North Dakota Department of Transportation

ADDENDUM 1 – JOB 2

TO: All prospective bidders on projects SOIA-7-085(096)192, Job No. 2 scheduled for the May 22, 2014 bid opening.

SRF No. 7594

Revised 5/12/2014	STATE	PROJECT NO.	SECTION NO.	SHEET NO.
	ND	SOIA-7-085(096)192	11	16

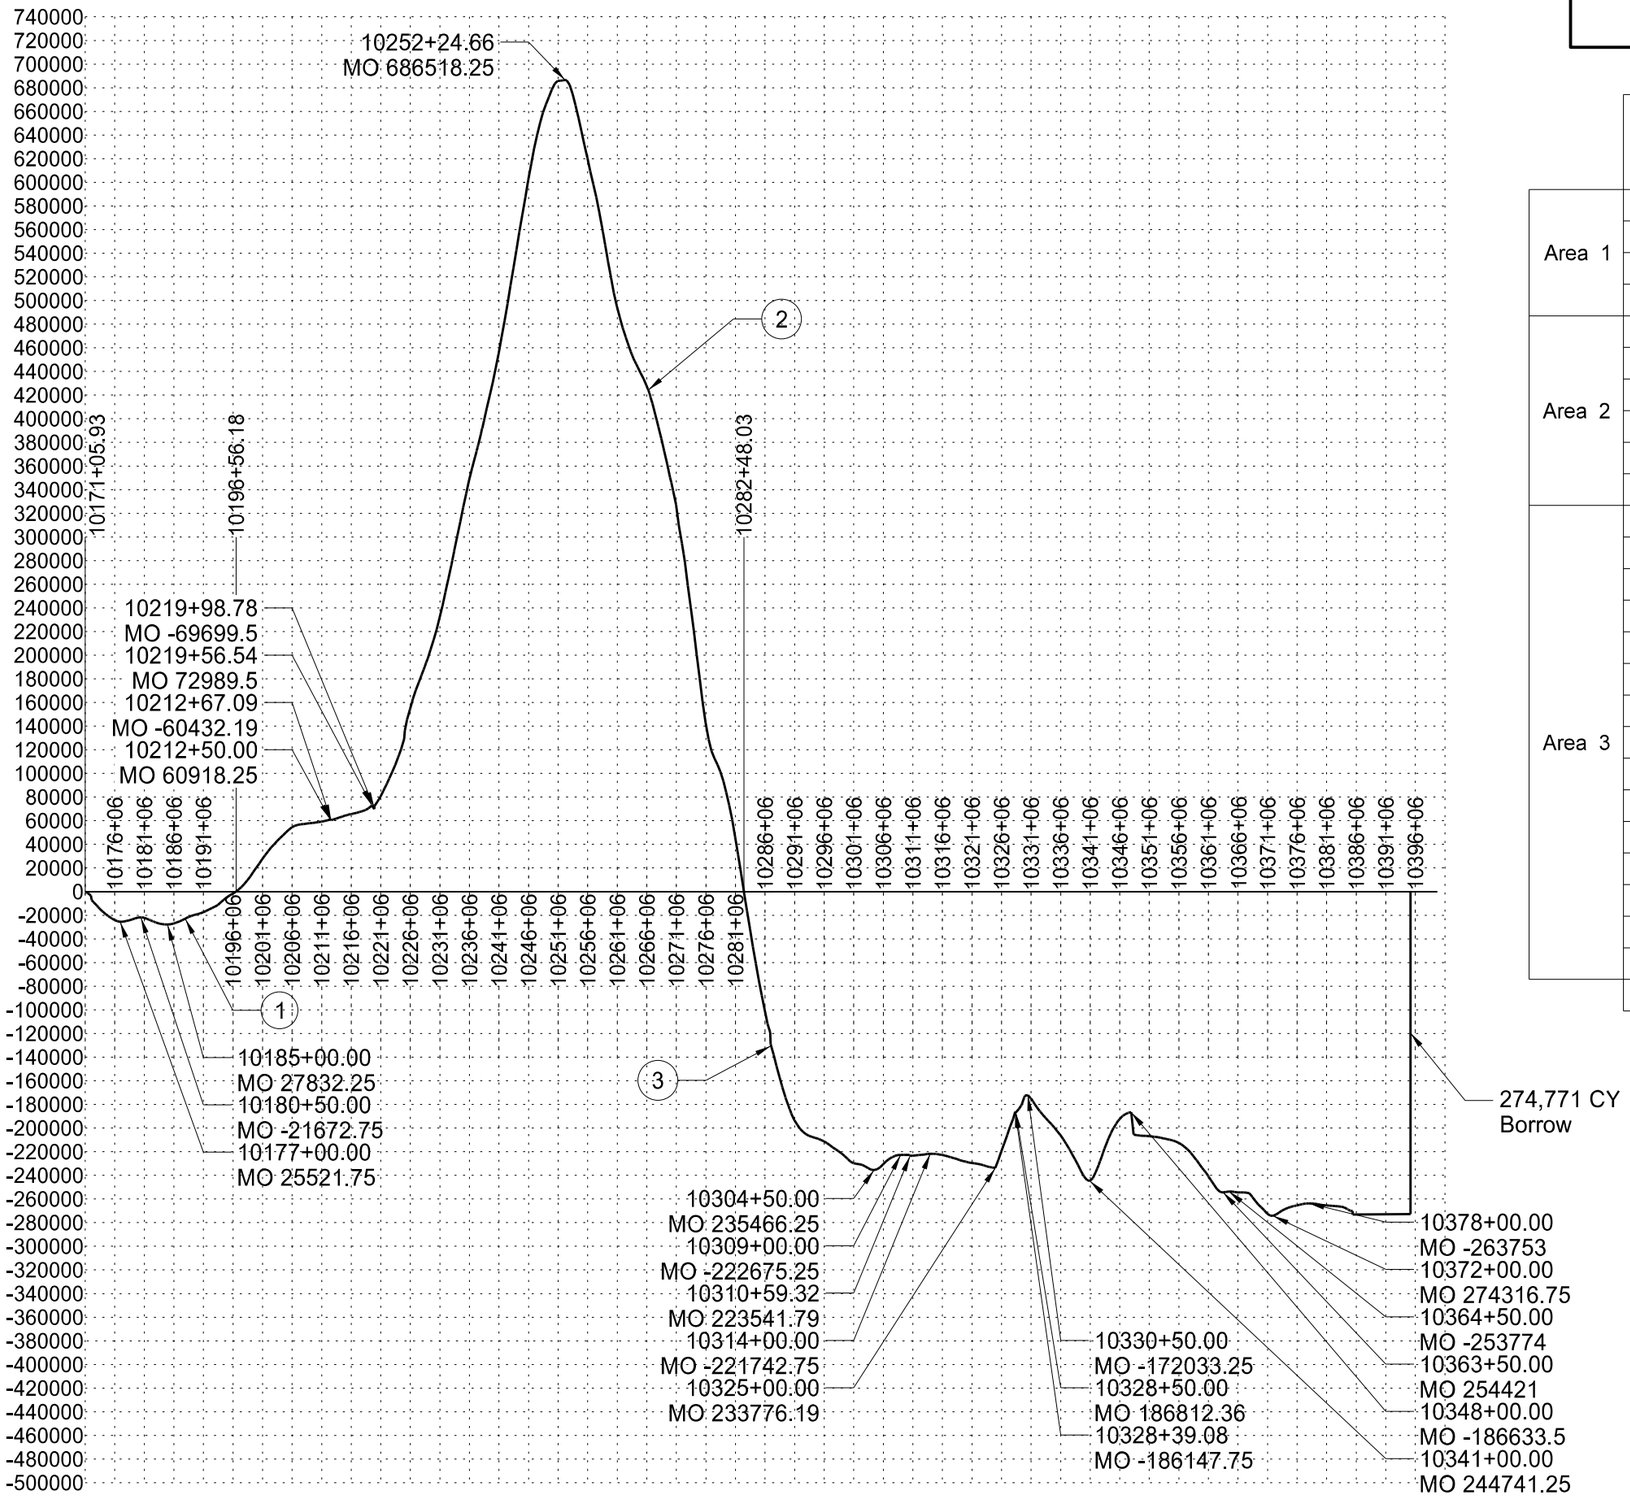
Sheet 11-16:
Revised Mass Diagram due to change in retaining wall.

Revised 5/13/2014	STATE	PROJECT NUMBER	SECTION NO.	SHEET NO.
	ND	SOIA-7-085(096)192	20	17

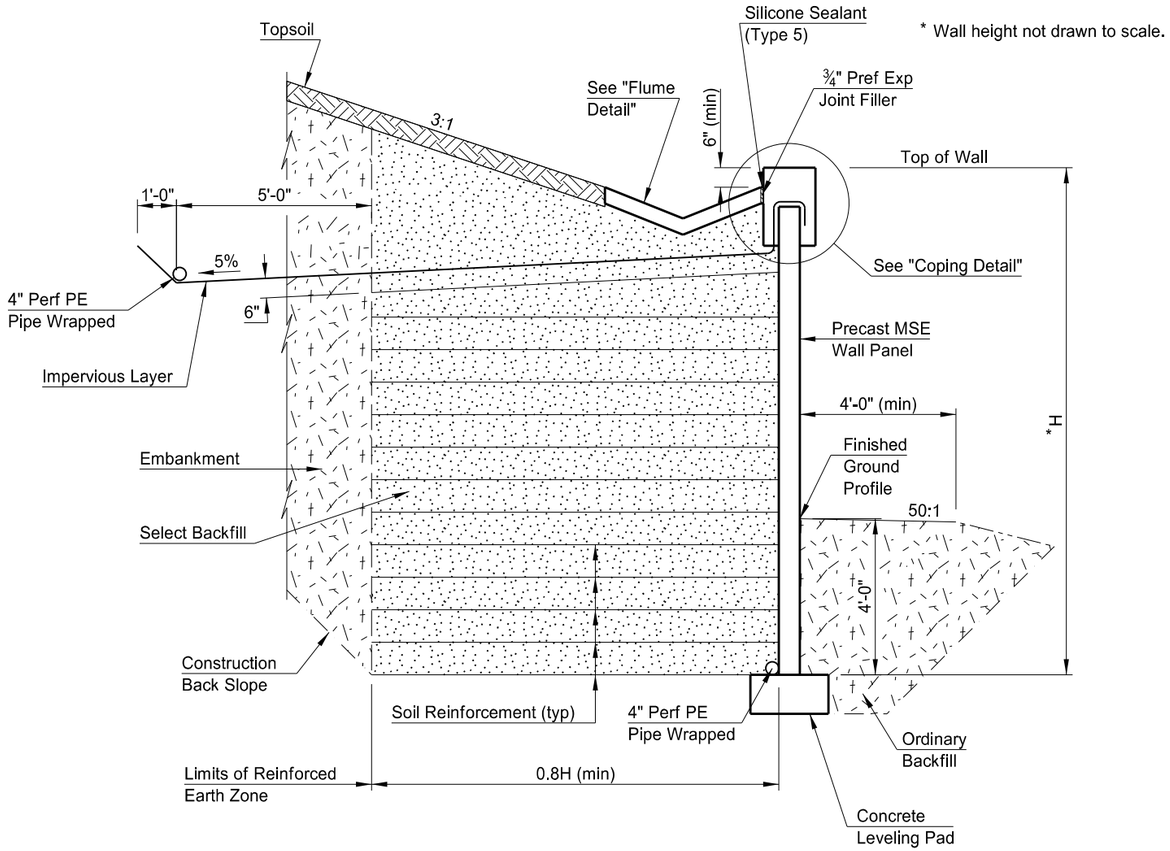
Sheet 20-17:
Revised retaining wall

Revised 5/12/2014	STATE	PROJECT NO.	SECTION NO.	SHEET NO.
	ND	SOIA-7-085(096)192	30	4

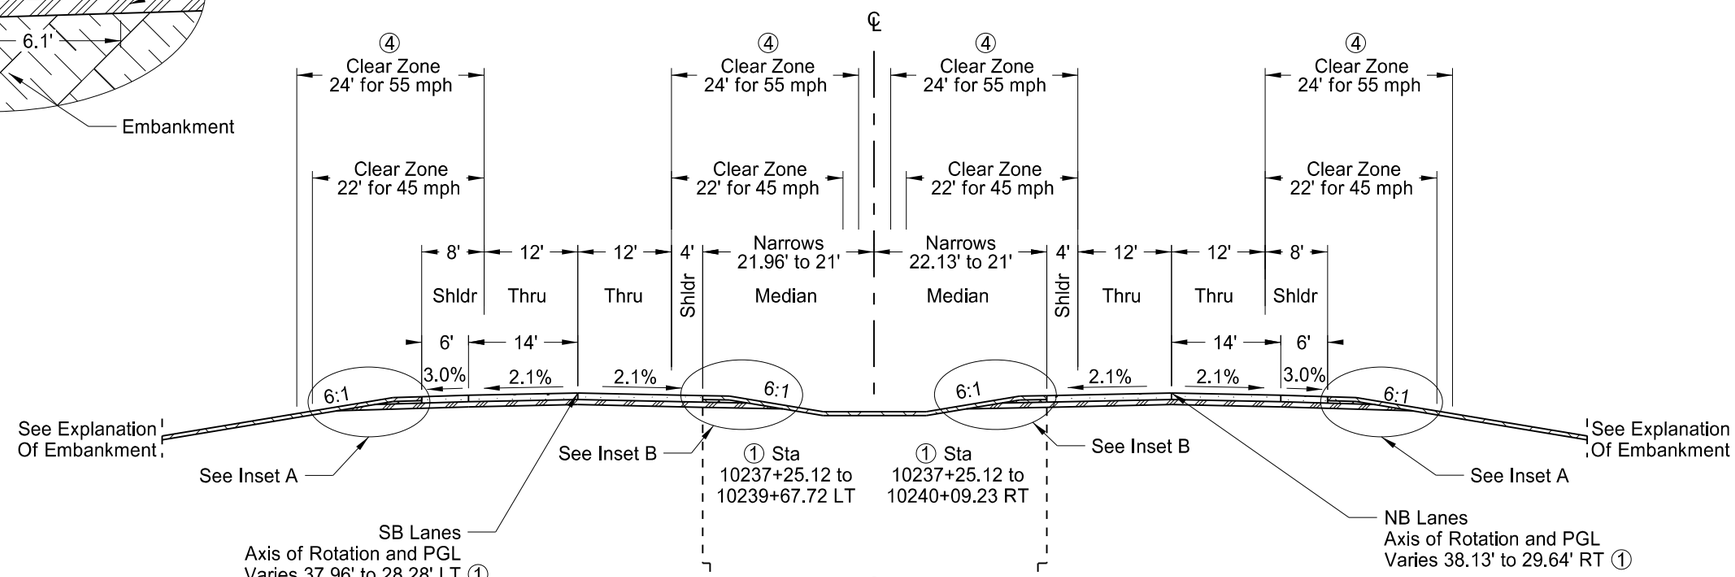
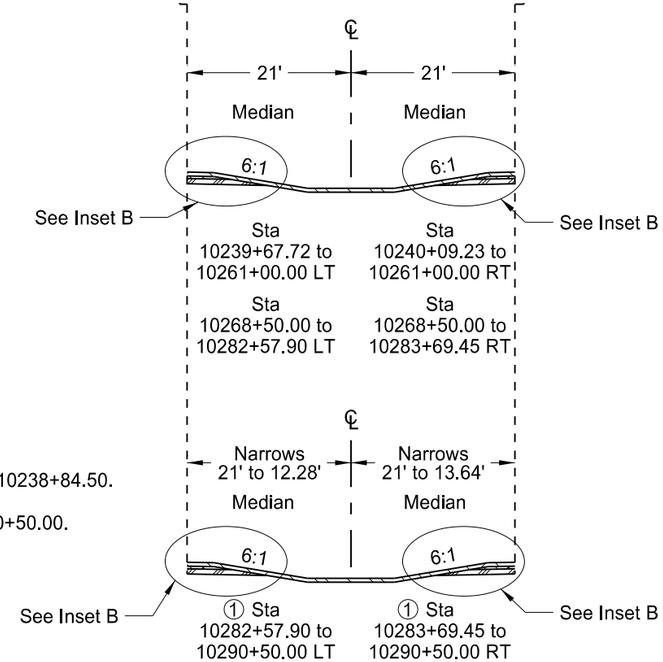
Sheet 30-4:
Revised typical due to change in retaining wall.

Revised 5/12/2014	STATE	PROJECT NO.	SECTION NO.	SHEET NO.
	ND	SOIA-7-085(096)192	30	5

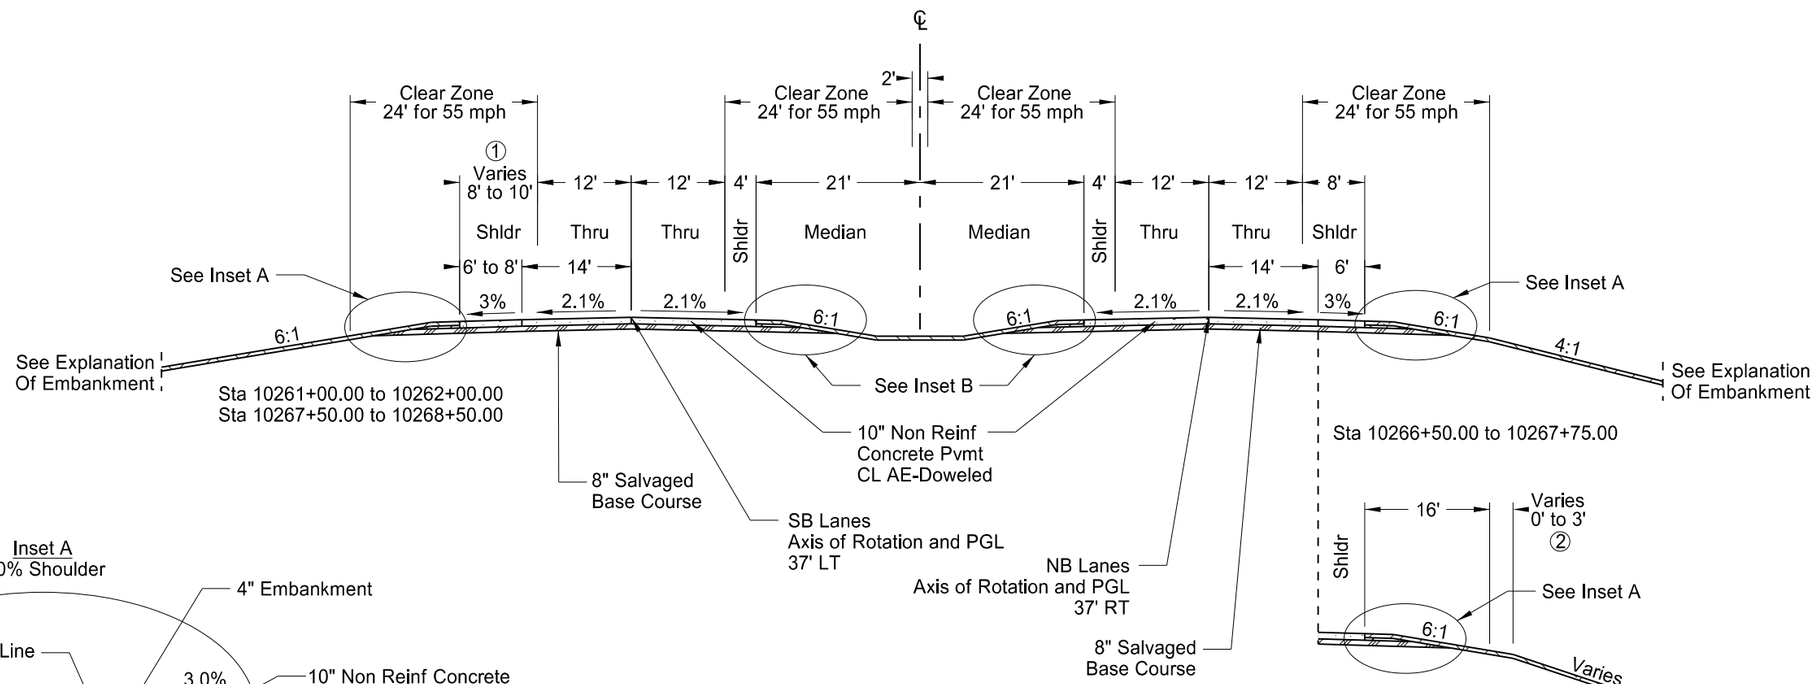
Sheet 30-5:
Revised typical due to change in retaining wall.

Revised 5/13/2014	STATE	PROJECT NO.	SECTION NO.	SHEET NO.
	ND	SOIA-7-085(096)192	30	6

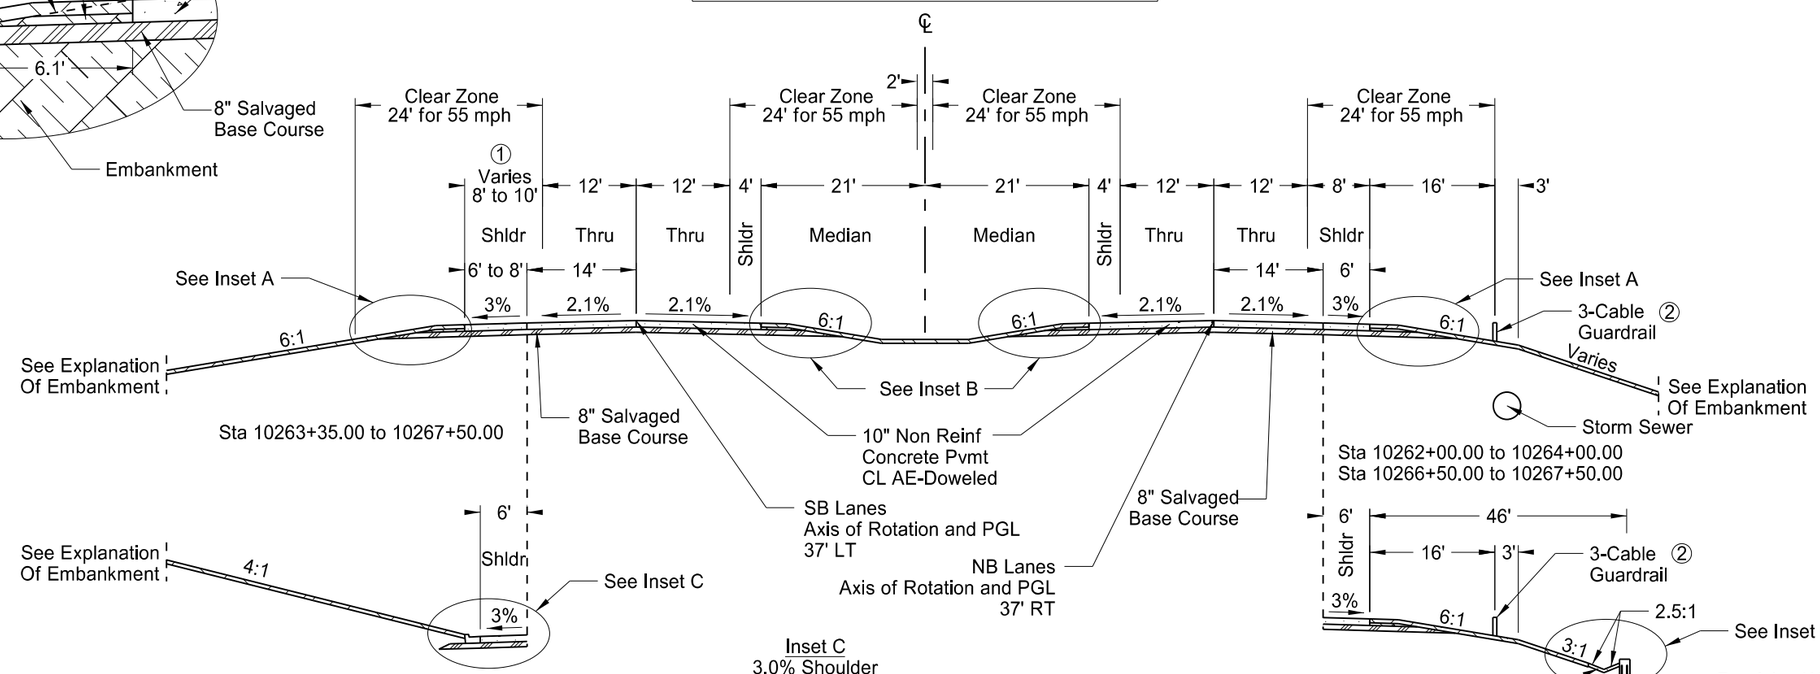
Sheet 30-6:
Revised typical due to change in retaining wall.

Revised 5/12/2014	STATE	PROJECT NO.	SECTION NO.	SHEET NO.
	ND	SOIA-7-085(096)192	60	2

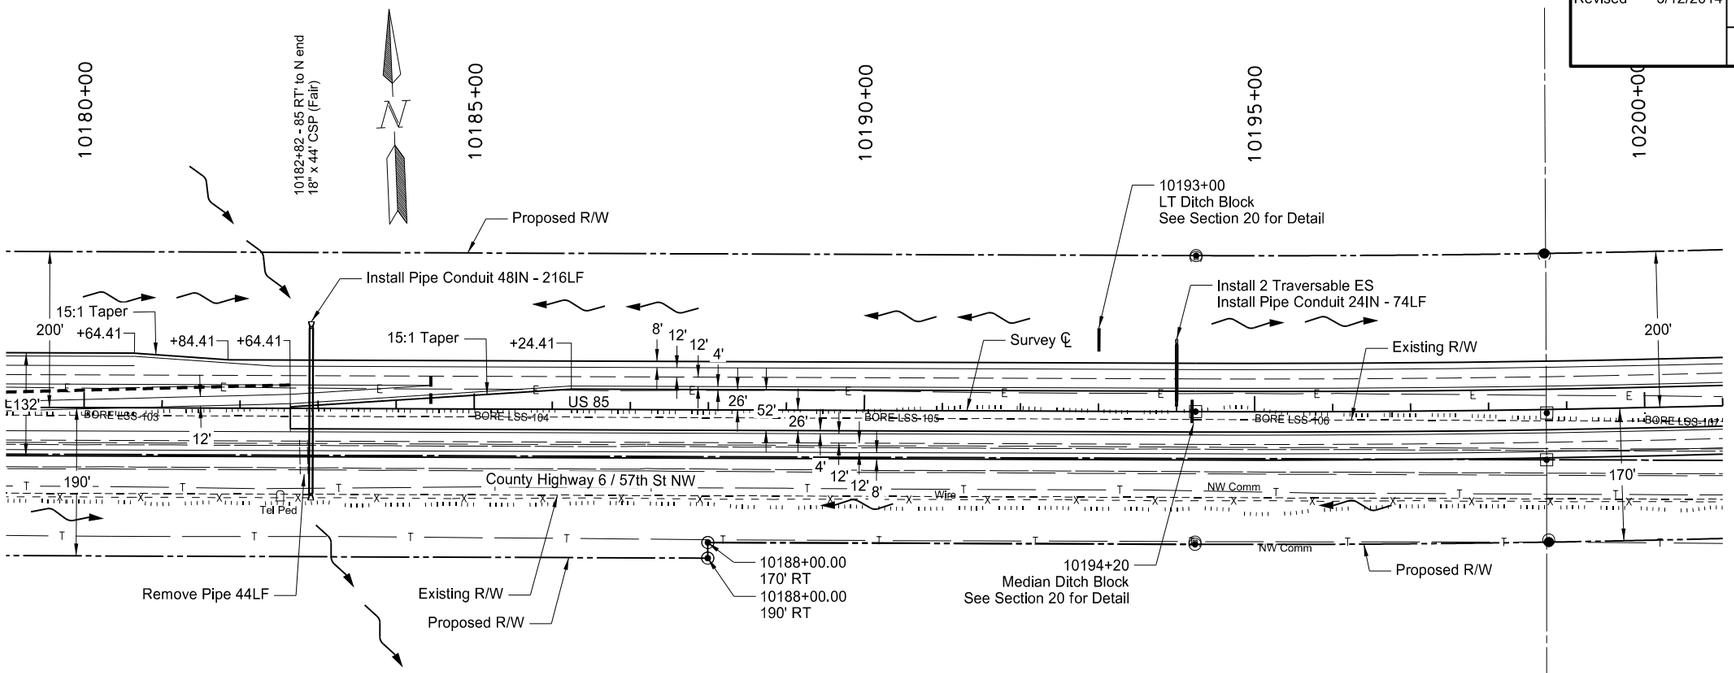
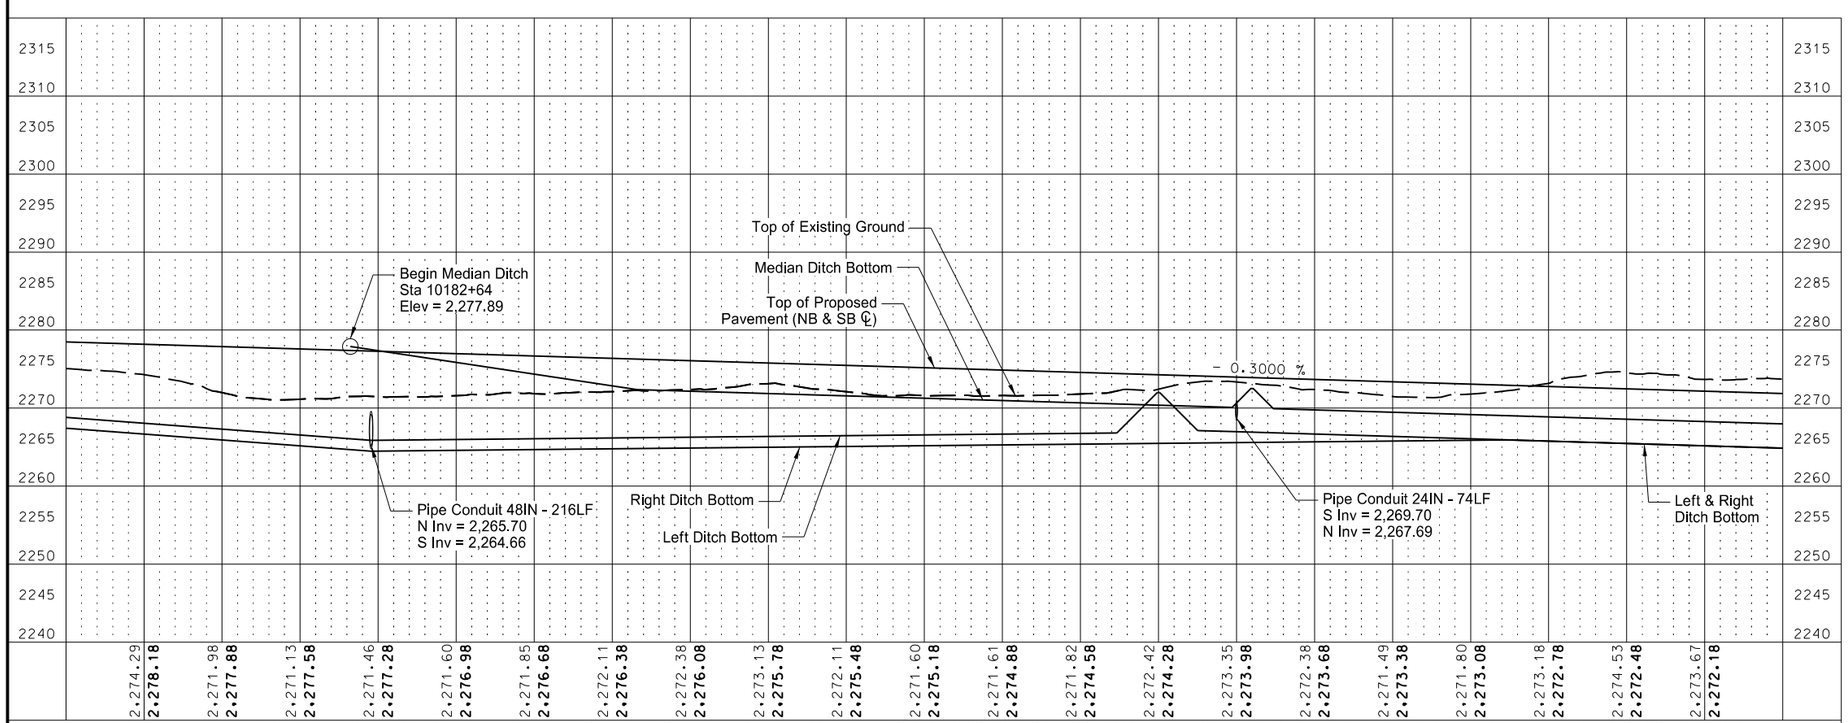
Sheet 60-2:
Revised pipe 10182+91 due to increase in drainage area.
